New Product Release: 720-MDO Version 8

15th January 2013

Wago plug detail

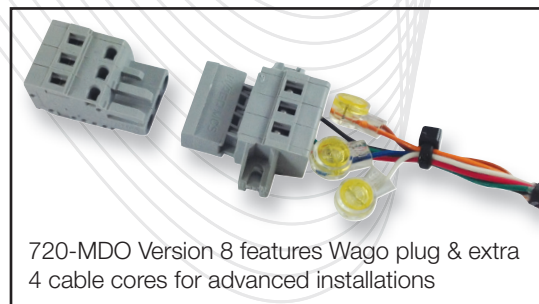
The 720-MDO Version 8 can be identified by its 7 core control cable. As well as the standard three cores terminated in the Wago plug (green, black and red), this has power supply wires from the Input stud (Brown core), Output stud (Blue core), and to the Printed Circuit Board/Motor supply (Orange and White cores). The additional four cores are pre-configured to save time on standard installations, but are easily accessed for advanced installations.

STANDARD INSTALLATION DRAWING:

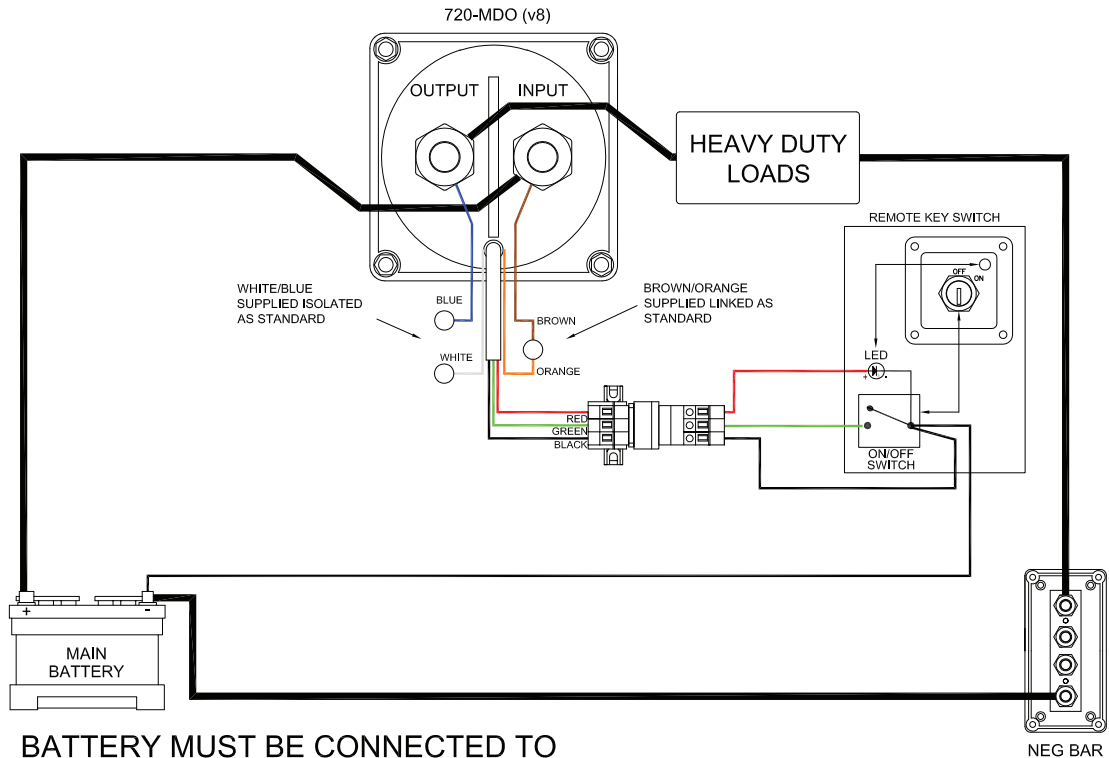
BATTERY MUST BE CONNECTED TO INPUT STUD WITH STANDARD INSTALLATION.

OPTIONAL INSTALLATION:

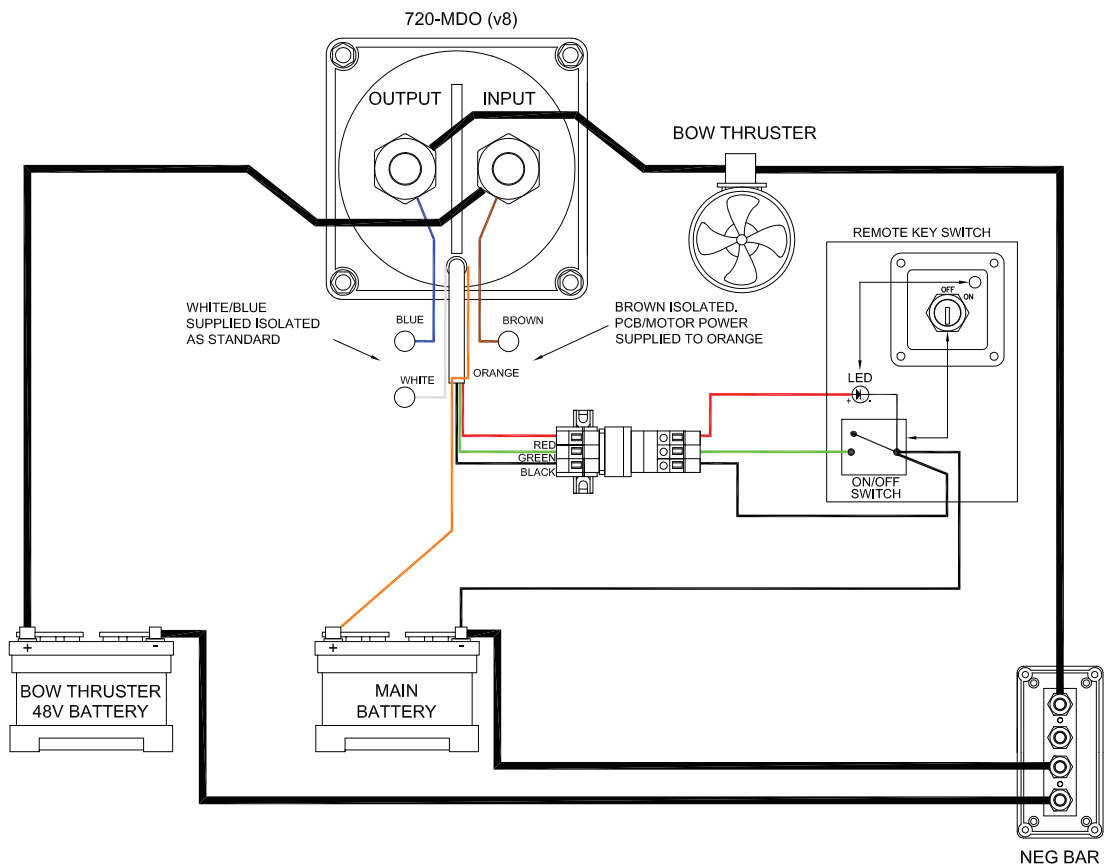
The 720-MDO Version 8 offers new installation options, whereby the motor/circuit board can be fed from either one, or two fully independent 12V or 24V supplies so the battery switch contacts are completely isolated, and can:

Switch contacts isolated from circuit board/motor supply

OPTIONAL INSTALLATION:
As a Parallel Switch

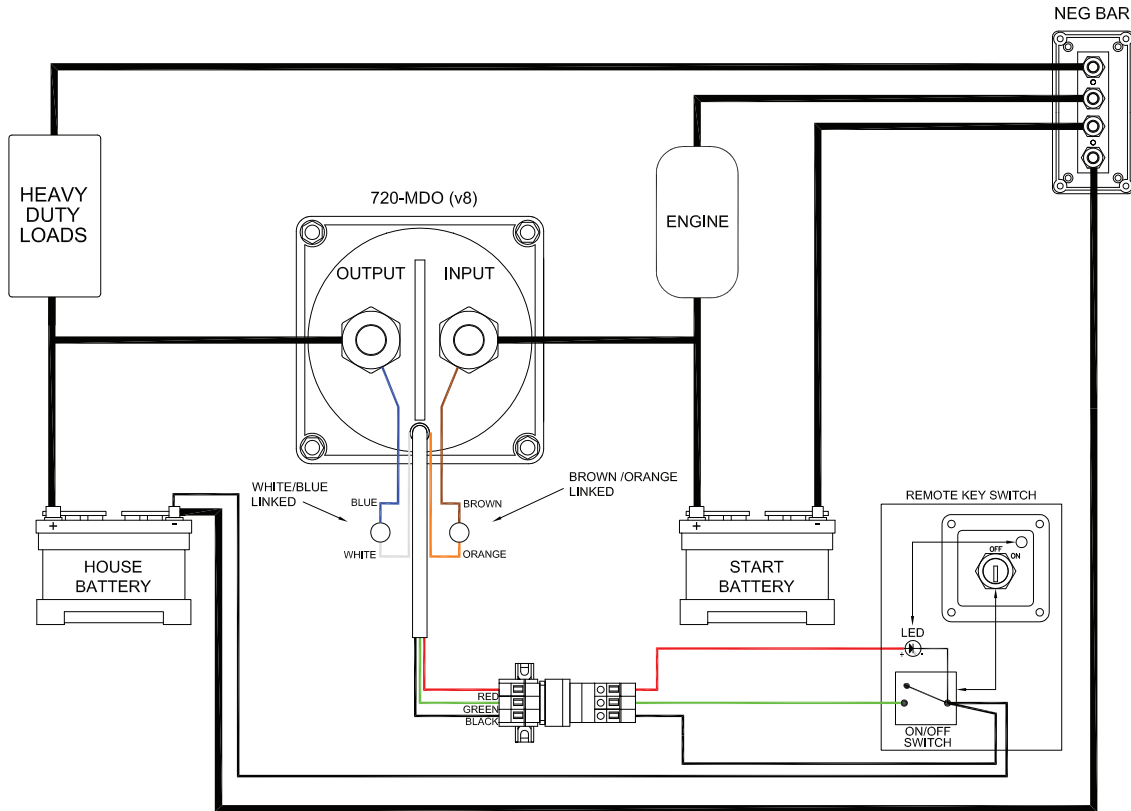
- Control higher voltage circuits e.g. 32 or 48 volt circuits
- Control negative cables in circuits (e.g. full remote isolation in metal hulled craft)
- Ensure engine electronic are fully isolated from all other circuits
- Still be operated in case of a flat battery
